RX470 rework SOP

Step 1、 Replace MLCC

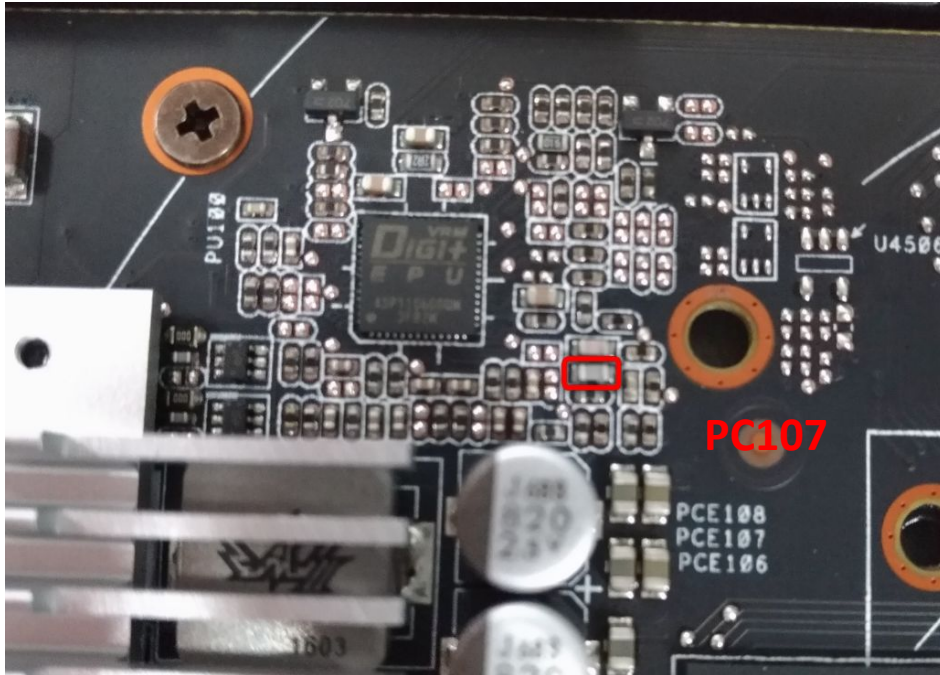
Replace the location MLCC of PC107
in red circle with 150 pf
(PN:11G233015104030)

Step2、 Remove MLCC between GND and DGND

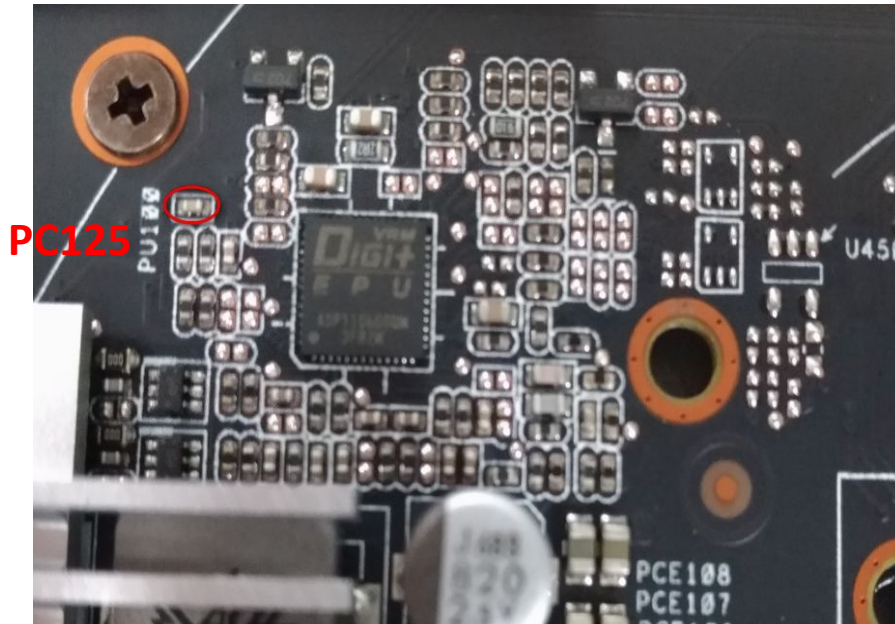
Remove the capacitance of location PC125 in the red circle of the picture
